City of Pawtucket, RI

***** **Addendum #1** *****

RFP # 15-011C

Veteran's Memorial Park Restroom Renovation

FLOOR PLAN

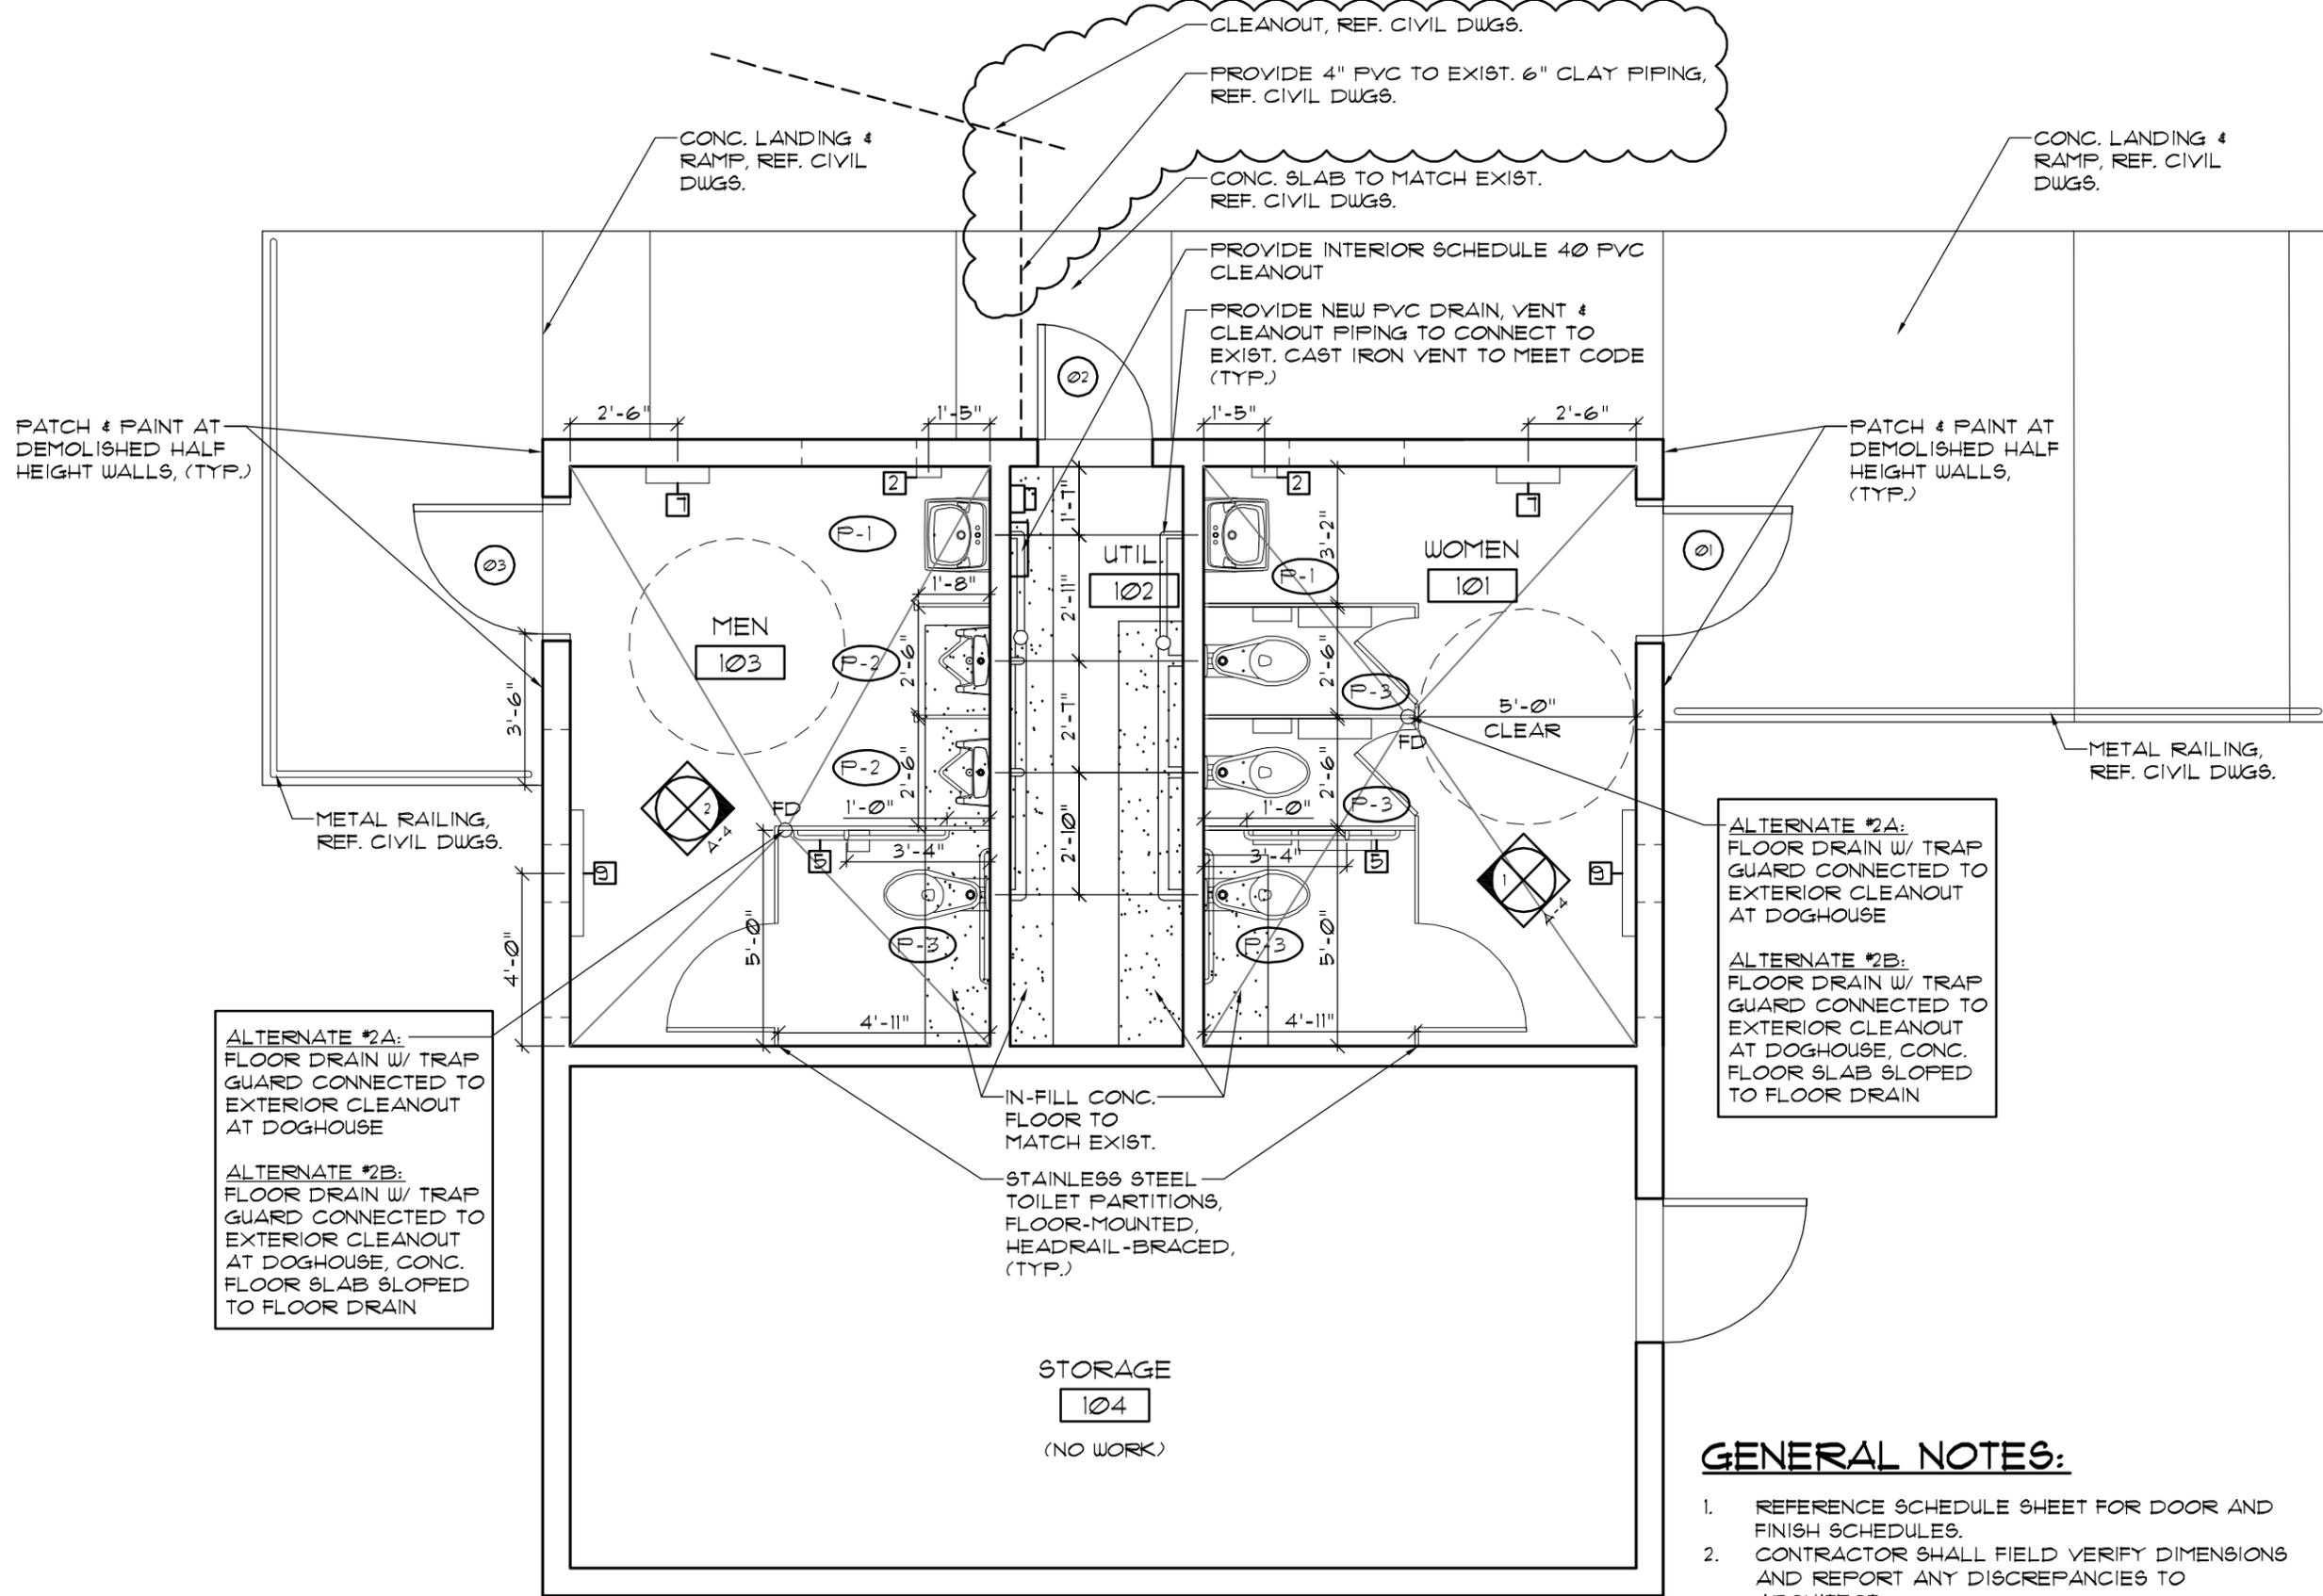
ITEM 3-1: Drawings A2, C2, C3, and C4

INSERT: Revised Drawings A2, C2, C3, and C4.
Drawings have been revised to reflect the following changes:

- *Eliminated proposed doghouse manhole structure*
- *Added proposed in-line 6” PVC cleanout structure in landscaped area adjacent to building*
